Access Compliance Report

Public Rights-of-Way

Intersection ID: 53017	Main Street: STEEL_HOUSE_BV	Cross Street: CHARTRES_LN	Location: SW
ADA ID: DA08849D45E1	Ramp Type: Perp	Initial Pass/Fail: Pass	Overall Compliance: No
		Severity Score: 10

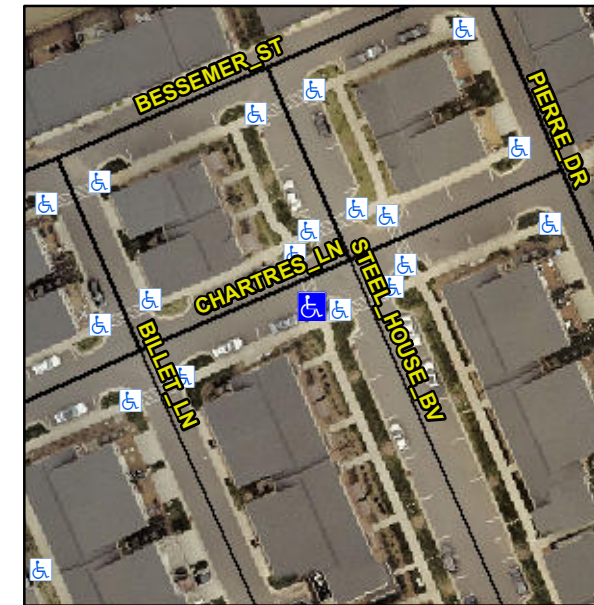
**R304.2.2-Perp, R304.3.2-Para,
R305.1.4, R305.2, R302.7.2**

**Remove & Replace Entire Ramp.
Grind Gutter Lip.**
